RE: Report on Ventilation Outlet Above-Limit Reading M4 East Motorway – 6 June 2020

SNC-Lavalin Atkins has been appointed by Fulton Hogan EGIS OM (FHEOM) Joint Venture to perform the Independent Air Quality Specialist roles for the M4 East Motorway, and were approved by the NSW Department of Planning, Industry and Environment (DPIE) on 14 May 2019.

Report on Ventilation Outlet above-limit reading WestConnex M4 East To be submitted to DPE within 20 days of the Report of Above-Limit Reading					
Details of the exceedance Attach relevant Notification of Above-limit Reading	<p>This report has been prepared to address the requirements under MCoA E16:</p> <p>“Should the results of monitoring show that any of the ventilation outlet limits specified in condition E14 have been exceeded, the proponent must immediately notify the Secretary, EPA and NSW Health. The notification must be followed up with a detailed report within 20 working days, which must be prepared by the proponent, reviewed by a suitably qualified and experienced independent specialist(s), and submitted to the Secretary, on the cause and major contributor of the exceedance and the options available to prevent recurrence.”<

2.2.5 VOC 1 hr average

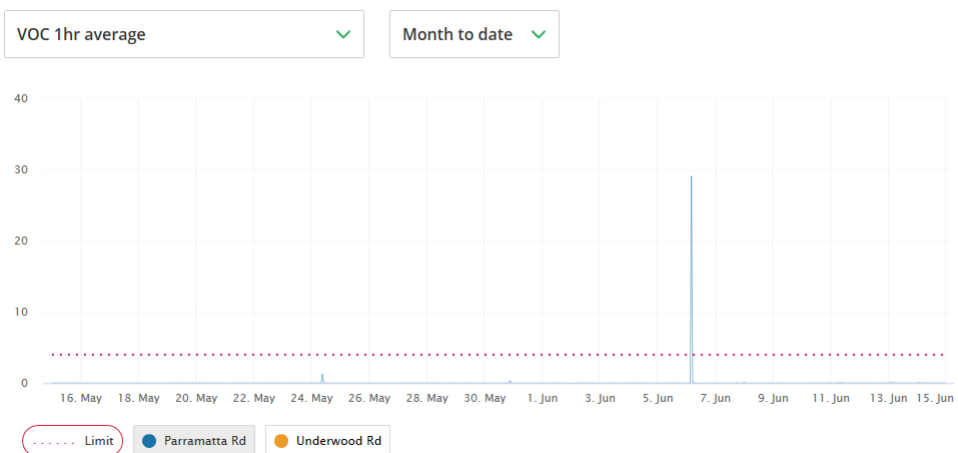
1. The report and data identify a potential exceedance of the Volatile Organic Compound (VOC) concentration limit on 6 June 2020 at the PRVF. There were no other exceedances for any of the other recorded pollutants (solid particles, NO_x, NO₂, or CO).
2. The monitoring data shown in Section 2.25 of the VOECC report clearly outlines that on 6 June from around 0400hrs, a distinct and sharp increase is evident where above-limit reading concentrations for VOCs at the PRVF were recorded, followed by a distinct and sharp decrease shortly after. The specified limit for VOC concentrations in the ventilation

outlets is 4.0mg/m³. The hourly average above-limit-reading recorded on 6 June 2020 was 29.1 mg/m³ during the period 0400hrs – 0500hrs which is outside of standard peak hour periods.
